TECHNICAL ADDENDUM

Project No.: R.068431.001

Project title/Titre du projet
EMERSON, MANITOBA
HIGHWAY 75, UNITED STATES BORDER

EXPANSION AND
REDEVELOPMENT OF THE
EMERSON PORT OF ENTRY

Drawing title/Titre du dessin
DETAILS - SHEET 1

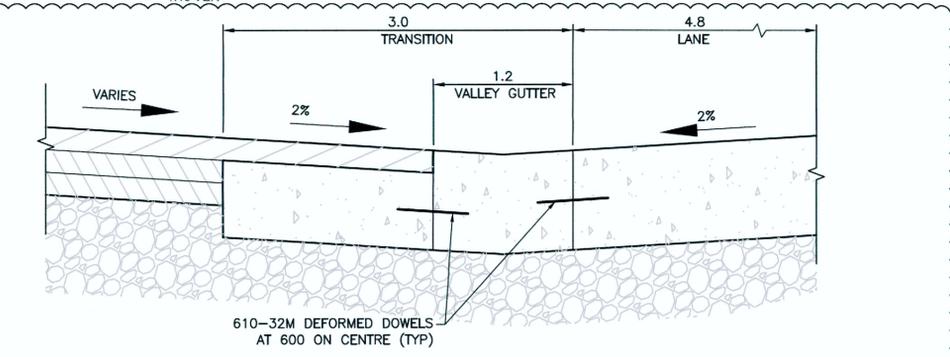
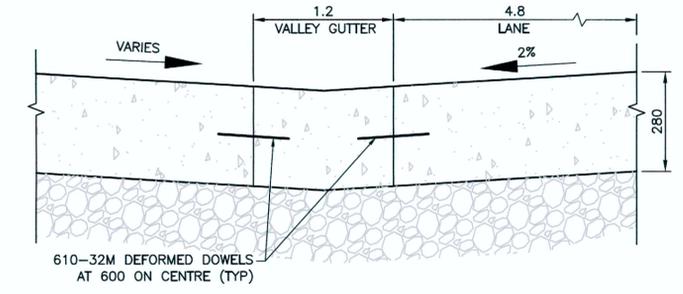
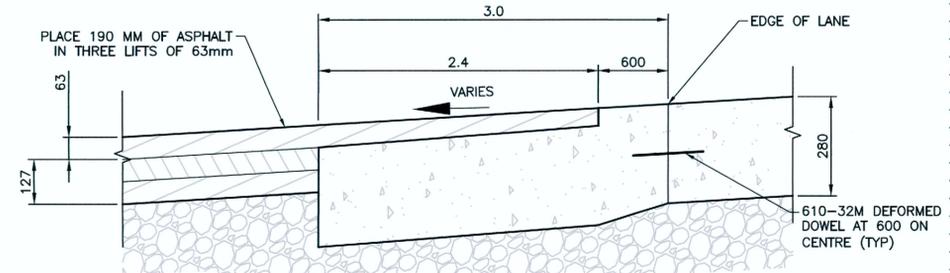
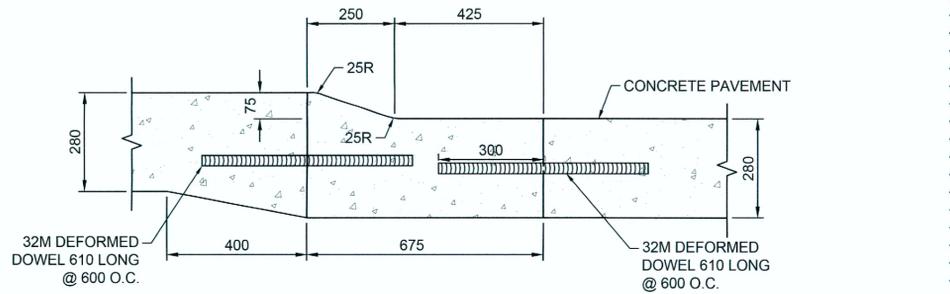
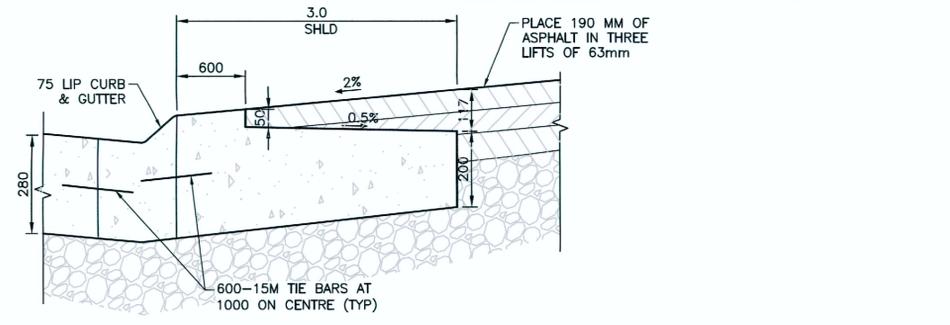
- .6 What are the reinforcing requirements for the 280mm thick concrete roadway. Dowel detail, etc.?

See Drawing "C15 - Rev 3" (attached as part of this Amendment) for clarification on the pavement reinforcing details.

- NOTES:
1. FIELD VERIFY ALL UTILITY LOCATIONS AND BOUNDARIES PRIOR TO COMMENCING WORK.
 2. INCLUDE ALL TESTING, TELEVISION, COMMISSIONING AND/OR PERMITS ASSOCIATED WITH THE WORKS.
 3. SMOOTH DOWELS SHALL BE PLACED AT 300mm INTERVALS FROM CENTER TO CENTER. THE SMOOTH DOWELS SHALL BE PLACED AT A MINIMUM OF 100mm BUT NO MORE THAN 200mm AWAY FROM ANY LONGITUDINAL JOINT AND OUTER EDGES OF CONCRETE.
